Technical Service Bulletin

Topic	Boot hinge access covers Flying Spur MY25
Market area	Bentley: worldwide (2WBE), China 796 VW Import Comp. Ltd (Vico), Beijing (6796)
Brand	Bentley
Transaction No.	2077175/1
Level	EH
Status	Released for publishing
Release date	Apr 25, 2025

Boot hinge access covers – To fit

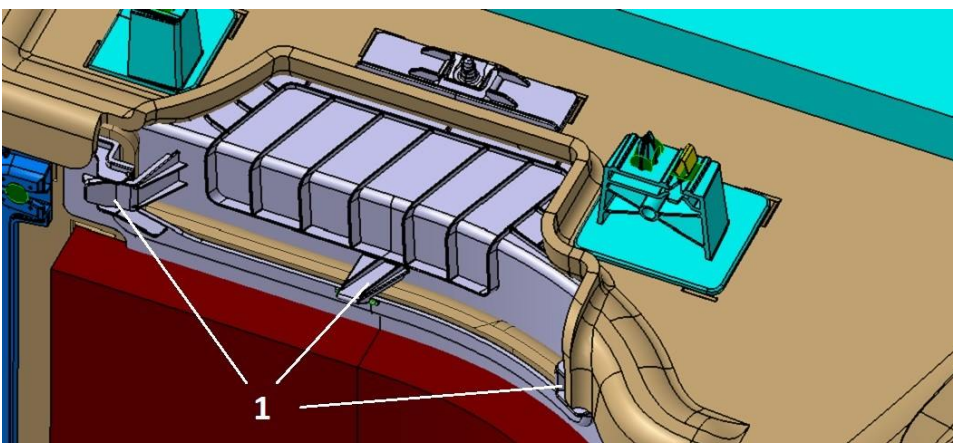
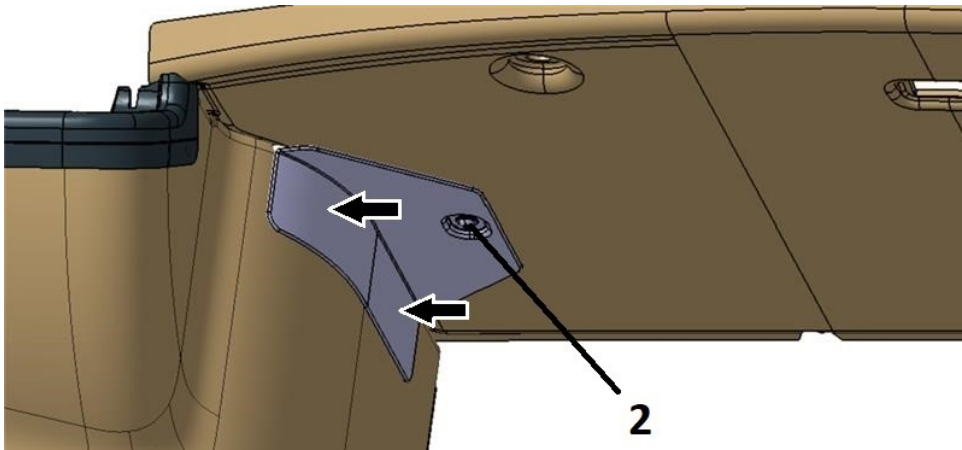
Customer complaint of exposed boot hinge area.

Customer feedback highlighted concerns about the exposed boot hinge area. Bentley has introduced boot hinge covers which are now only available to retrofit upon customer request. See solution below.

1. Align the cover with the mounting position, ensuring the clips (1) are correctly positioned.
2. Press the cover firmly until all three clips engage securely.
3. Insert the fixing screw (2) and tighten by hand to ensure proper alignment.
4. Torque the screw to 2NM.

Ensure the clips are aligned with the slots in the body before pushing in to prevent damaging the clips.
